Access Compliance Report

Public Rights-of-Way

| Intersection ID: 17113 | Main Street: STERLING_RD | Cross Street: WESTFIELD_RD | Location: NE |
| ADA ID: B32C6E0733B6 | Ramp Type: PerpDiag | Initial Pass/Fail: Fail | Overall Compliance: No |

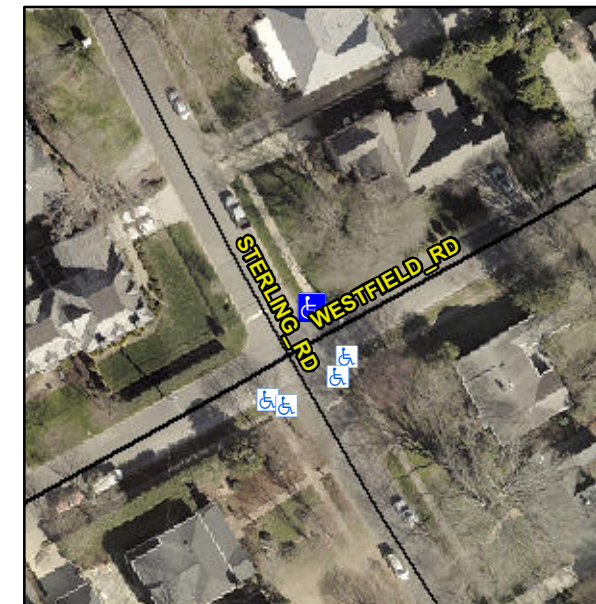
Not Found, R304.5.3

| Compliance | Description | Data | Compliance | Description | Data |
|------------|-----------------------|-------|------------|-----------------------------|-------|
| Yes | Ramp Width (in) | 49.0 | No | Ramp XSlope (%) | 4.6 |

Remove & Replace Curb Ramp With Two New Directional Ramps or Equivalent.
